Re: Revised Colusa Subbasin Groundwater Sustainability Plan

AquAlliance, the California Sportfishing Protection Alliance, and the California Water Impact Network (hereinafter AquAlliance) submit the following comments and questions on the Revised Colusa Subbasin Groundwater Sustainability Plan (“Revised GSP” or “Plan”) to the Colusa Groundwater Authority and the Glenn Groundwater Authority GSAs (“GSAs”).

- Active Gas Storage
- Idle Gas: Dry Gas; Liquid Gas
- Plugged Gas: Dry Gas; Liquid Gas
- Permitted Gas: Dry Gas; Liquid Gas

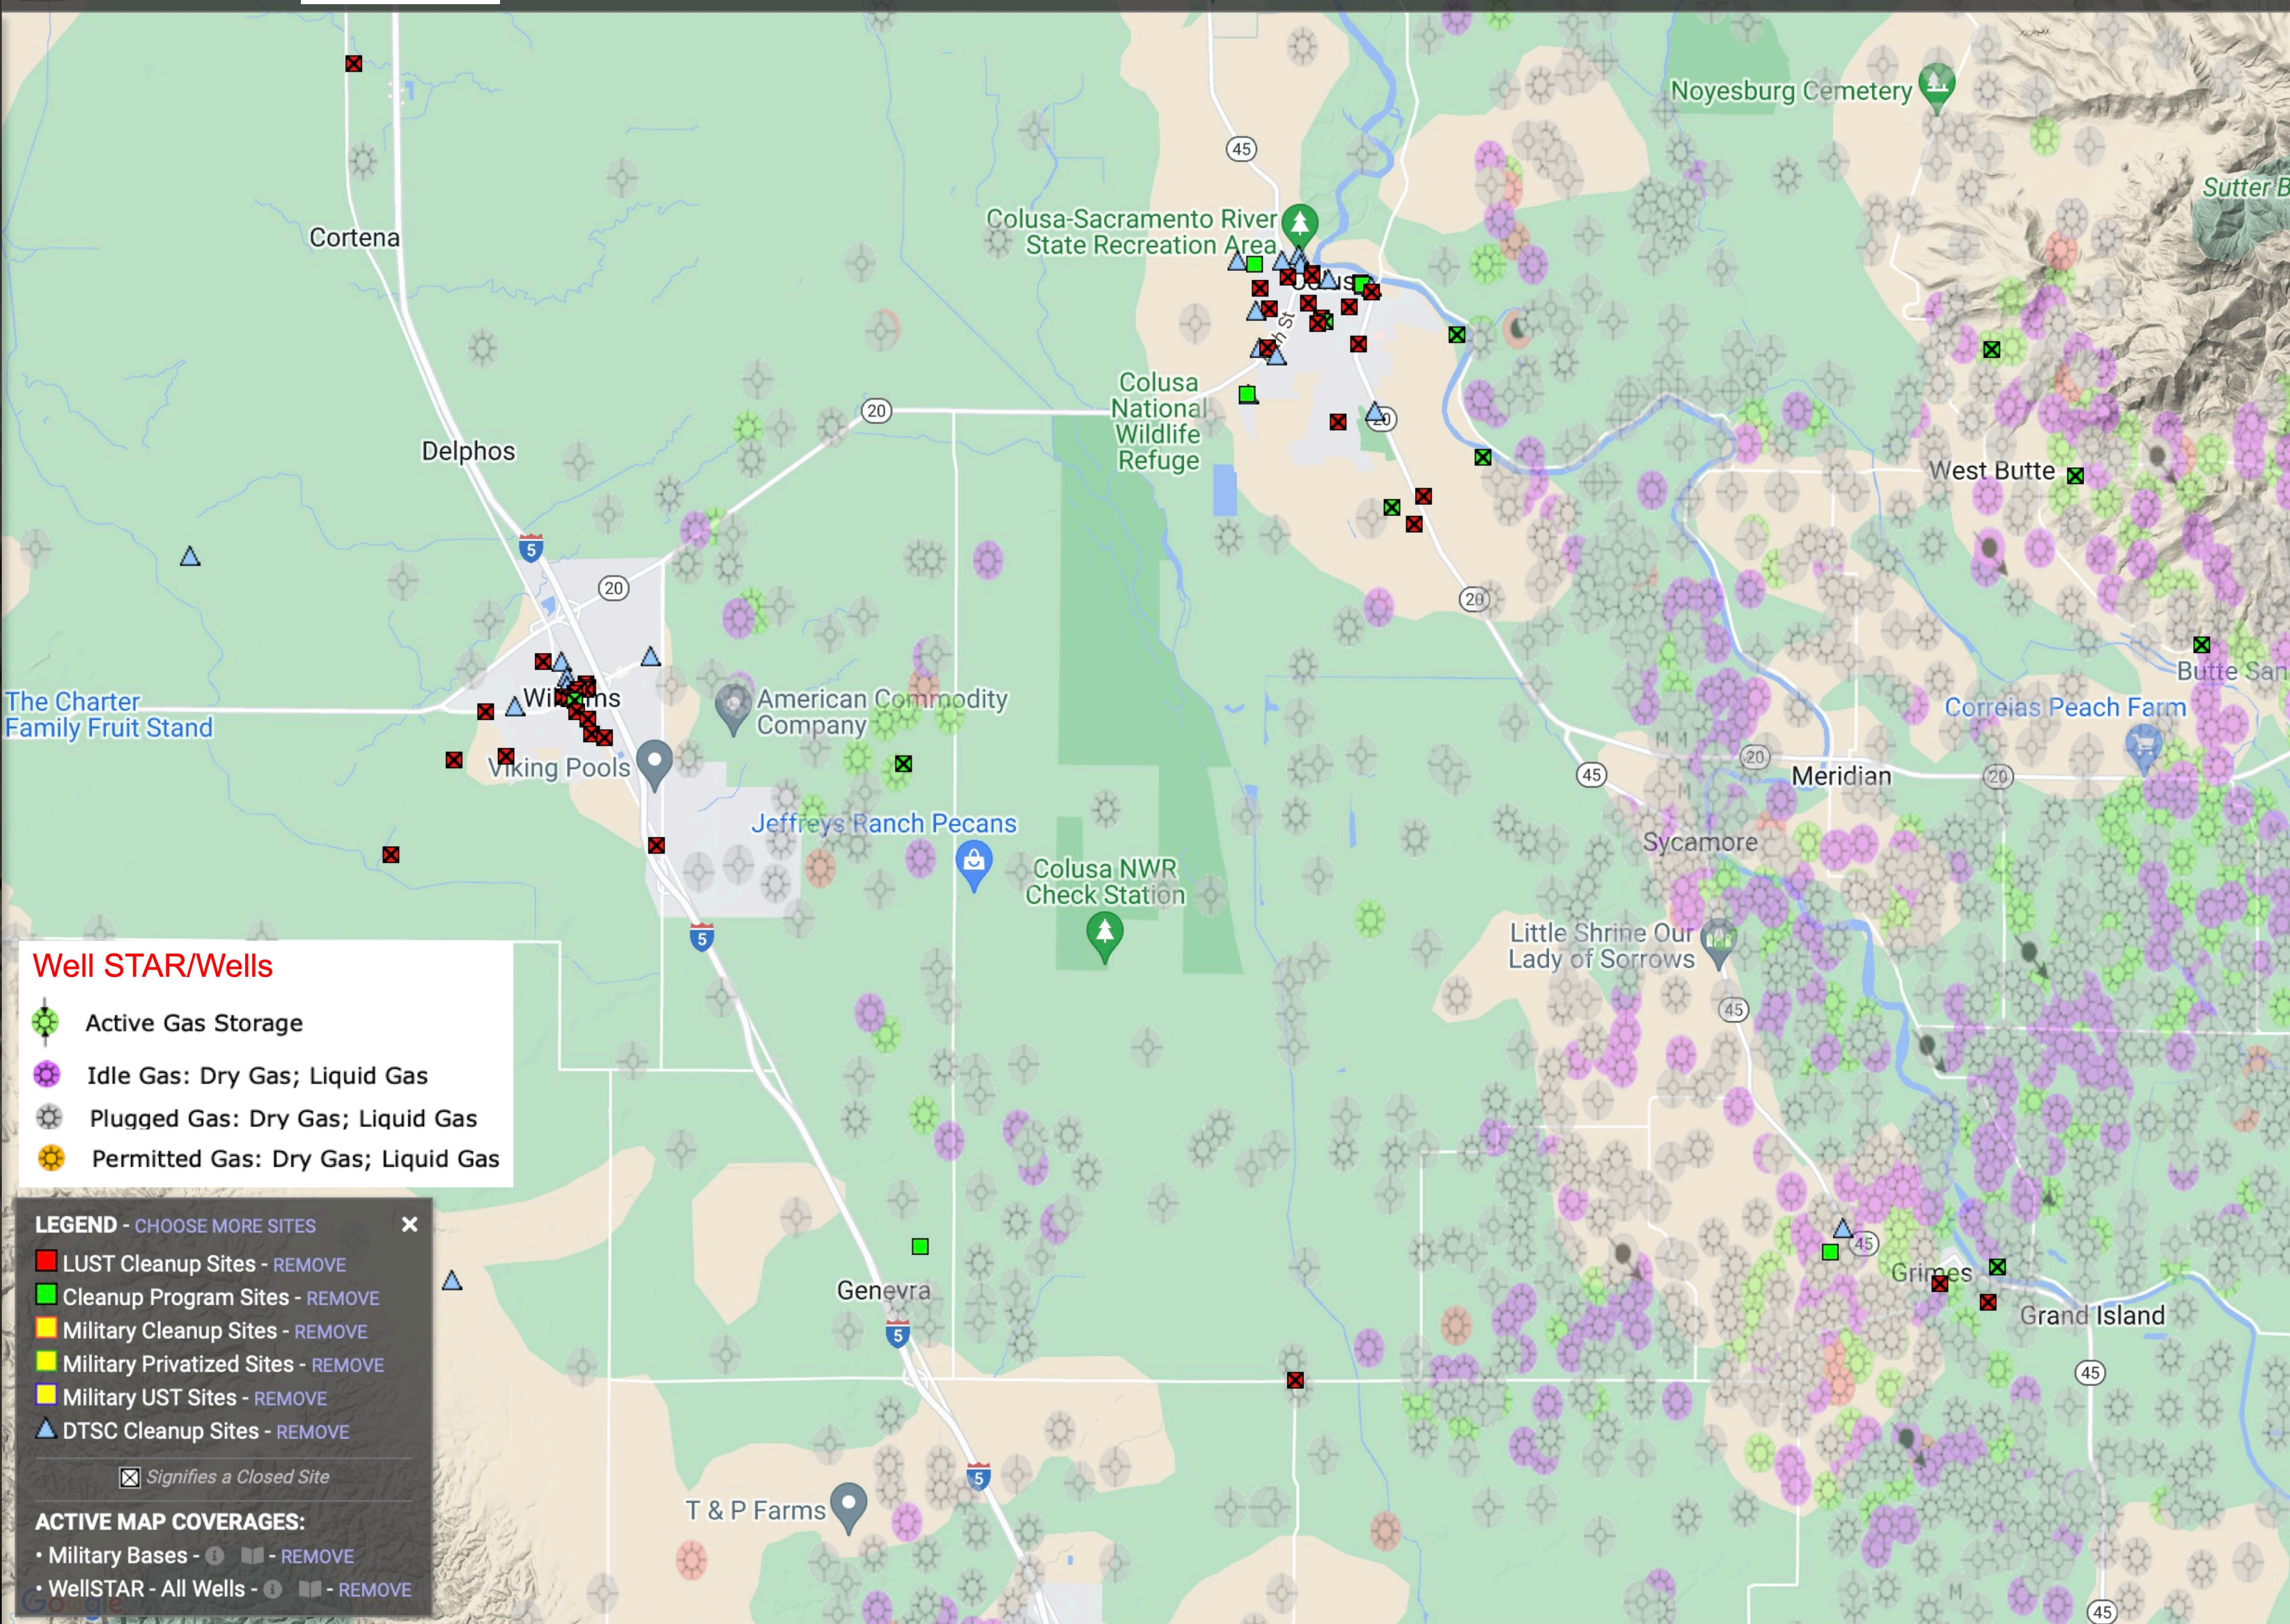
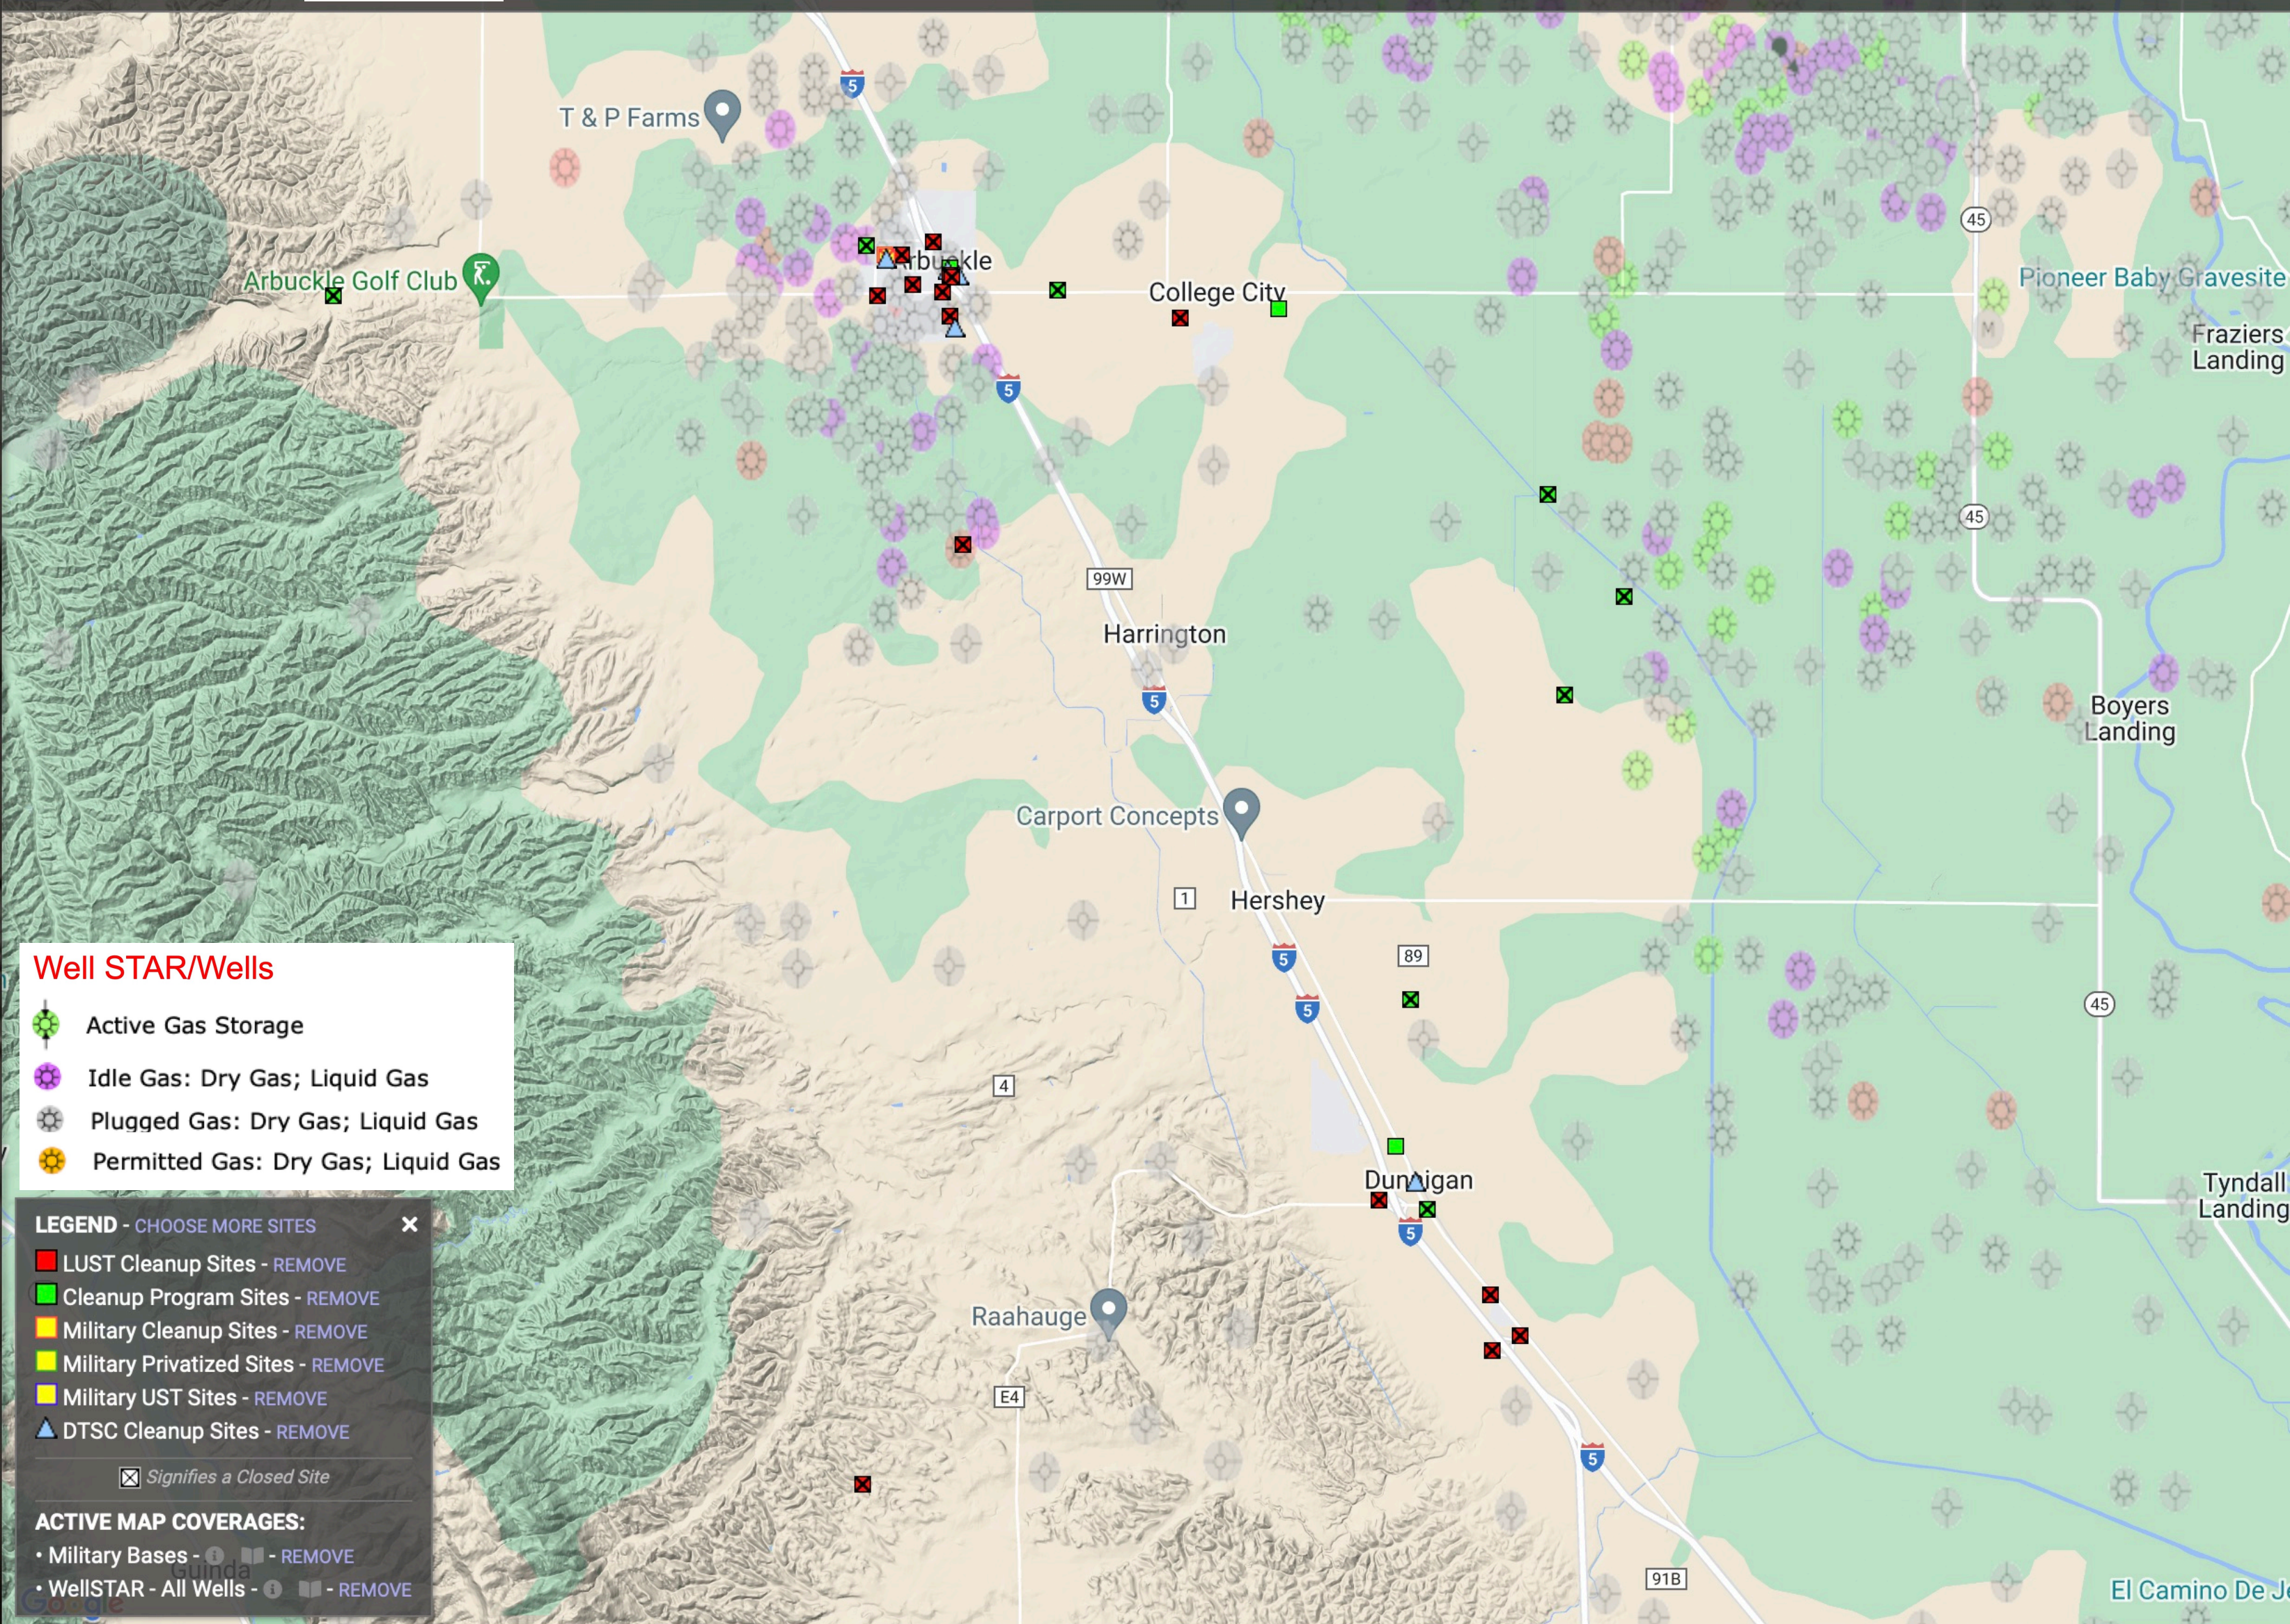
The attached six screen captures of the Geotracker website show that there are a number of known contaminated sites and oil and gas wells throughout the Subbasin. The Revised GSP doesn't provide an analysis of whether the monitoring network shown in Figure 4-3 is adequate to collect sufficient data to demonstrate short-term, seasonal, and long-term trends in groundwater for known contaminants for each applicable principal aquifer to determine groundwater quality trends for water quality indicators to address known water quality issues (CCR § 354.34(a), (c)(4)).
